Mookodi Integration Phase 2: Proposed Construction of the Mookodi - Ganyesa 132kV Power Line, proposed Ganyesa Substation, and Havelock LILO, North West Province

Draft Environmental Authorisation Amendment Motivation Report

DEA Reference Number: 14/12/16/3/3/1/680/AM2
Issue Date: 26th July 2017
Revision No.: 1
Project No.: 13993

Figure 1: Proposed New Ganyesa Substation Locality Map

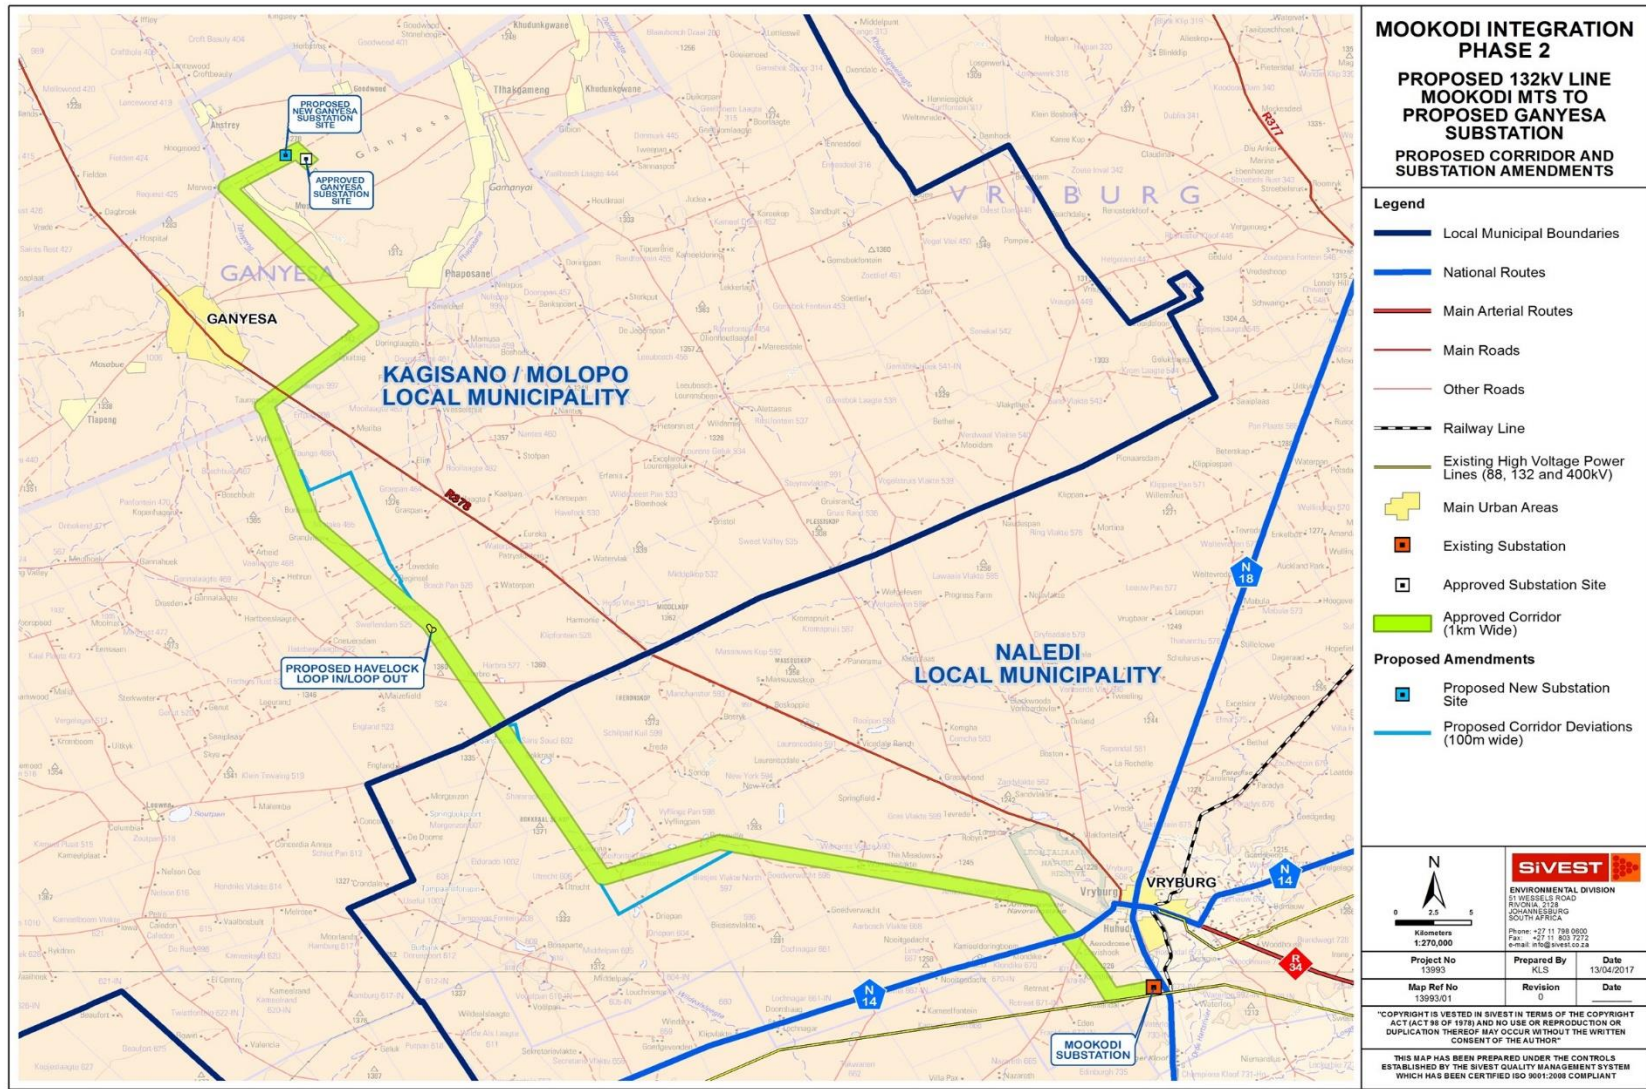
The above incorrect co-ordinates need to be amended as shown in **Table 5** below. A map showing the location of the correct position of the Ganyesa Substation is shown in **Figure 1** below.

Substation Alternative 2 (Preferred)	Latitude	Longitude
Centre point of activity	26° 29.528' S	24° 13.733' E
